TECHNICAL BULLETIN

Water pump new version

24-1090 / PA1090 / 101090

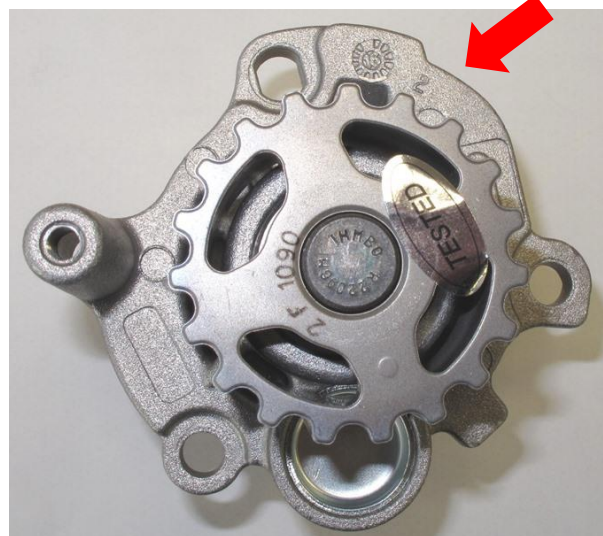
The water pump 24-1090/PA1090/101090 new version differs from the current version only in the housing. The arrows highlight the different shape of the housing external edge, which being less bulky it is interchangeable with the current version.
